California Regional Water Quality Control Board

RE: INVESTIGATIVE ORDER NO. R9-2008- 0047, INVESTIGATION OF SIGNIFICANT PHYSICAL EVIDENCE OF RELEASE, RAMONA LANDFILL, SAN DIEGO COUNTY

INVESTIGATIVE ORDER NO. R9-2008-0047
FOR
RAMONA LANDFILL INC.
RAMONA LANDFILL
SAN DIEGO COUNTY

Landfill Inspection Report

Photo #1, taken around 10:30 a.m. Stained soil on southern sideslope.

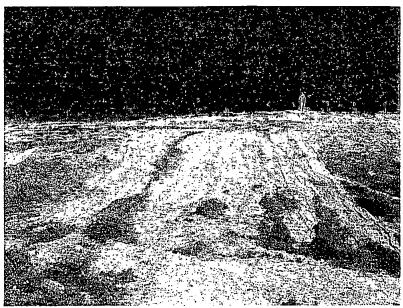
Four areas of stained soil were noted during the site inspection on the southern sideslope. Two of the stained areas can be seen in photo #3. All of the areas with stained soil appeared to originate at the same elevation. Photo #2 provides a closeup of a small amount of ponded liquid. The ponded liquid was noted in the longest stained area, which extended down to the access road. Exposed waste and erosion were noted on both the southern and eastern sideslope. An erosion gully approximately one foot in depth (see photo #4) was noted on the southern sideslope. Exposed wasted is noted in photos # 5, 6 and 7. Erosion gullies on the eastern sideslope are documented on photo #8.

Photo #7, taken around 11:00 a.m.

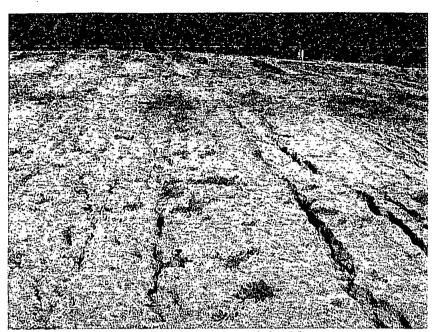
Other Nuisance Condition	seeps noted.
Yes	Precipitation/Drainage Controls	
Yes	Is Drainage System Adequate?*	No
	*If no, identify: Erosion, Downcutting, Flooding, Ponding, Does Not Control Peak Flows	See erosion noted in photos 4, 7 and 8.
Yes	Water Quality Monitoring Program	
	Type of Monitoring Program: Surface Water,	
	Groundwater, Unsaturated Zone, Condensate,	Ground water, surface water, leachate
Yes	Leachate, Other	monitoring
Yes	Is Monitoring Program Adequate?*	
·	*If no, identify: Construction Problem, Broken, Could Not Find, Unknown	
No	Samples Collected? (sample no. & location)
